Service Bulletin

SB 427-110414; Bell 427 Air Conditioner Blower Motor Connector

Bell Helicopter Model 427 equipped with the Air Comm Corporation

427EC-200-1 thru -4 air conditioning systems

Figure 1 Aft Evaporator Blower Assembly (blower configuration may differ slightly. Connector is used on all 427 aft evaporators)

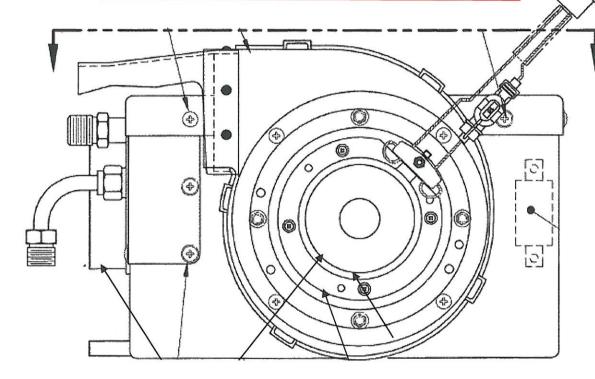
Locate each connector as shown in Figures 1 and 2. De-mate each connector and inspect both mates for signs of overheating, discoloration or plastic deformation. Gently pull (estimated 5-7 lb force) on each wire to verify the integrity of the contact's crimp. The contacts should be fully seated and locked in the housing so pulling gently on the wires will not dislodge the contacts from the housings.

Inspect this connector and its mate

Note that the pinout of the replacement connector set is not defined however the wire alignment across the connector set must remain unchanged.

If any signs of overheating of the housing are present or if the pull test fails, the system must be rendered inoperative and the connector housings and contacts replaced with new replacement connectors using Deutsch HDT-48-00 Crimping tool or equivalent MIL-DTL22520 Type 1 crimping tool before further operation. See Section B for information on how to contact Air Comm Corporation..

Assembly Contact Insertion (DTM, DT, DTP)

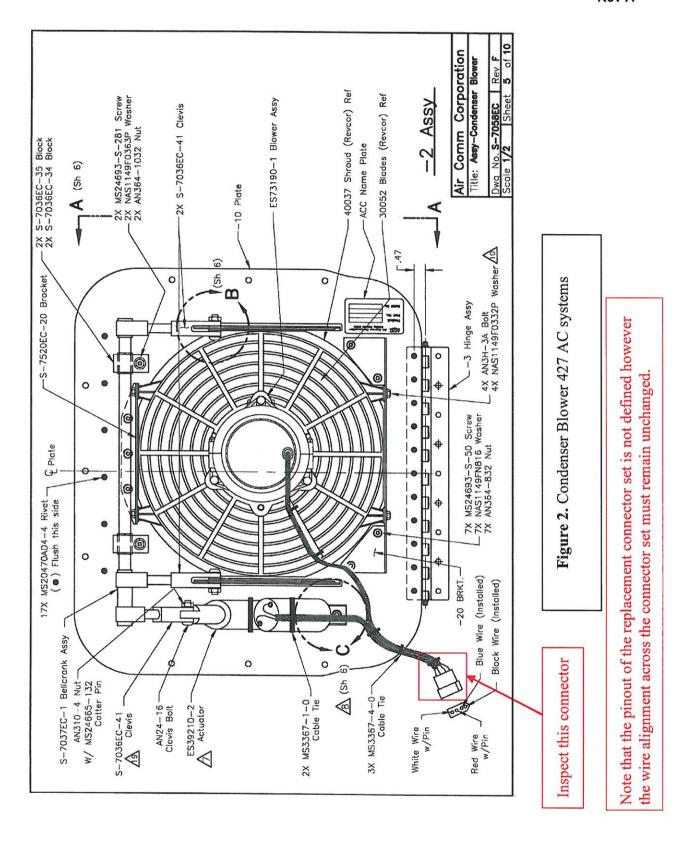
Installation instructions for new replacement connectors are per the view below and as shown on pages 3 thru 5.

Grasp crimped contact approximately 1.0" (25.4mm) behind the contact barrel.

2. Hold connector with rear grommet facing you.

3. Push contact straight into connector grommet until a click is felt. A slight tug will confirm that it is properly locked in place.

4. Once all contacts are in place, Insert orange wedge: receptades - with half holes aligning with contacts. Plugs - with contacts aligning behind full holes. The orange wedge will snap into place.

1. Remove orange wedge using needlenose pliers to pull wedge straight out.

2. To remove the contacts. gently pull wire backwards, while at the same time releasing the locking finger by moving it away from the contact with a screwdriver.

3. Hold the rear seal in place, as removing the contact will displace the seal.
